AMENDMENT OF SOLICITATION/MODIFICATION OF CONTRACT				1. CONTRACT ID CODE	PAGE 1 OF 3 PAGES
2. AMENDMENT/MODIFICATION NO. AMENDMENT NO. 0002		3. EFFECTIVE DATE 07/09/10	4. REQUISITION/PURCHASE REQ. NO.	5. PROJECT NO. (If applicable) 09-0205	
6. ISSUED BY CODE		CODE mks	7. ADMINISTERED BY (If other than Item 6) CODE See Item 6		
Officer in Charge of Construction MCI-East 1005 Michael Road Camp Lejeune, NC 28547-2521					
8. NAME AND ADDRESS OF CONTRACTOR (No., street, county, State and ZIP Code)				(X)	9A. AMENDMENT OF SOLICITATION NO. N40085-09-R-0205
				X	9B. DATED (SEE ITEM 11) 06/25/10
					10A. MODIFICATION OF CONTRACT/ORDER NO.
					10B. DATED (SEE ITEM 11)
CODE	FACILITY CODE

09-0205, Renovations of Galley, Building NH100

BASEMENT EXISTING ELECTRICAL EQUIPMENT ROOMS
 1/16"=1'-0"

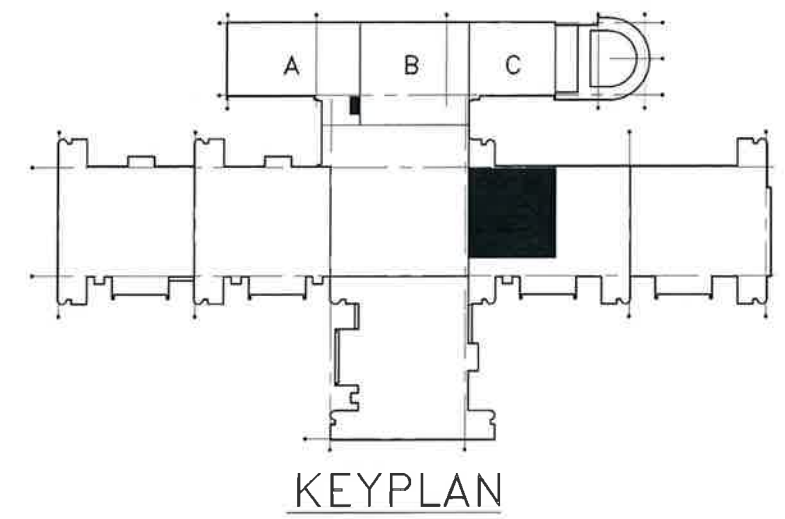
1. Question: On Drawing E-101 Keyed Note 2, 6, and 7 all make reference to the lighting circuits being routed to Electrical Equipment room 004. What is the location of the mentioned electrical equipment room for those panels?

1. Answer: Please see attachment which indicates the panel locations referred to in keyed notes 2, 6, and 7.
2. Question: On Drawing E-102 Keyed Note 5 references the relocation of BEMCC10. What is the preferred Conduit & Conductor size?
